PCN (Product Change Notice)

PCN Number: PCN_UtSTST_20260510 Affected Series: WE-STST, WE-LAN AQ Affected Part Number: see table below PCN Date: 2026-02-10 (YYYY-MM-DD) Effective Date: 2026-05-10 (YYYY-MM-DD)	Change Category: <input type="checkbox"/> Equipment/Location <input type="checkbox"/> General Data <input checked="" type="checkbox"/> Material <input type="checkbox"/> Process <input checked="" type="checkbox"/> Product Design <input type="checkbox"/> Shipping/Packaging <input type="checkbox"/> Supplier <input type="checkbox"/> Software
Contact: Product Management Phone: +49 (0) 7942 - 945 5001 Fax: +49 (0) 7942 - 945 5179 E-Mail: pcn.eisos@we-online.com	Datasheet Change: <input type="checkbox"/> Yes <input checked="" type="checkbox"/> No Attachment: <input type="checkbox"/> Yes <input checked="" type="checkbox"/> No

Affected part numbers:

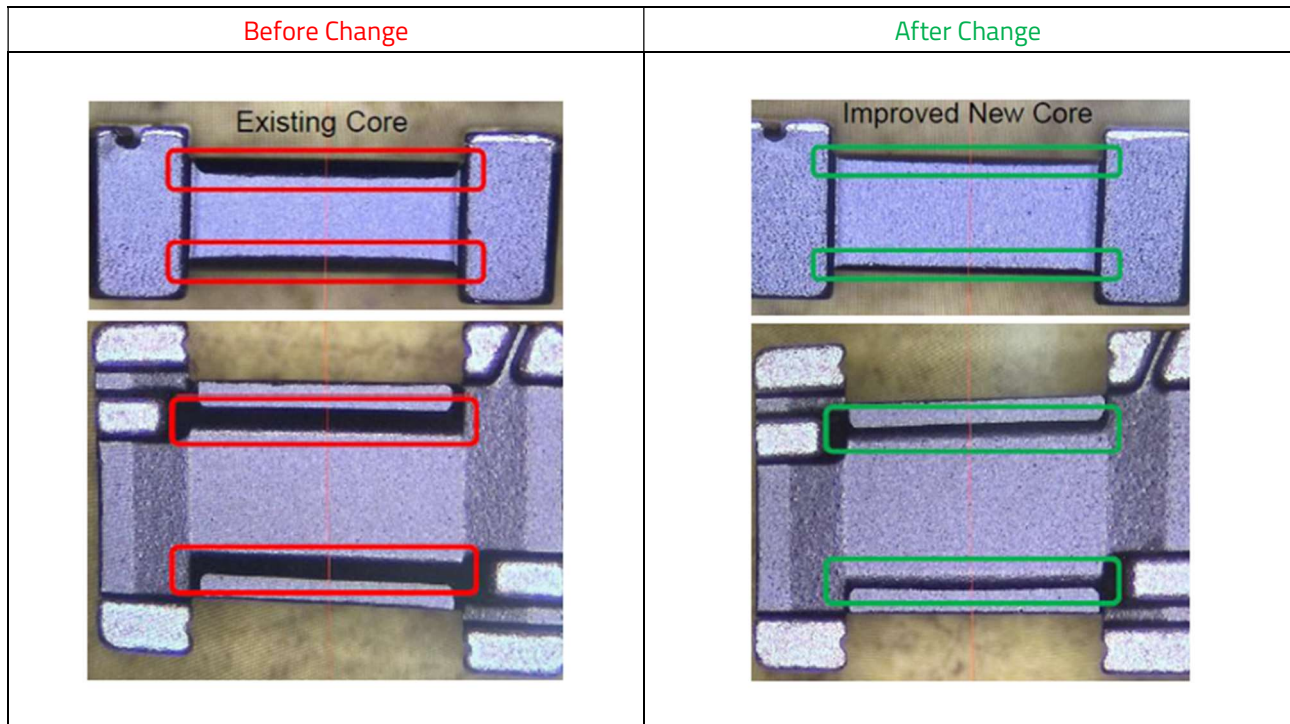
DESCRIPTION OF CHANGE:
 In order to enhance the product reliability, Würth Elektronik eiSos will change the wire and core sharp. There will be no change in fit, form, function, quality of the product. The new revision of the affected part numbers will be sent out after the previous revision is out of stock (according to FIFO - first-in, first-out).

- Wire change:

Before Change	After Change
Wire name:	Polyurethane wire, 180 °C	Polyurethane wire overcoated nylon, 180 °C
Supplier name:	DONGGUAN NISSEN CABLE CO LTD	JUNG SHING WIRE CO LTD
UL file number:	E204861	E174837

- Core sharp change: Reduce the R radius from 0.165 mm to 0.1 mm at the winding area.
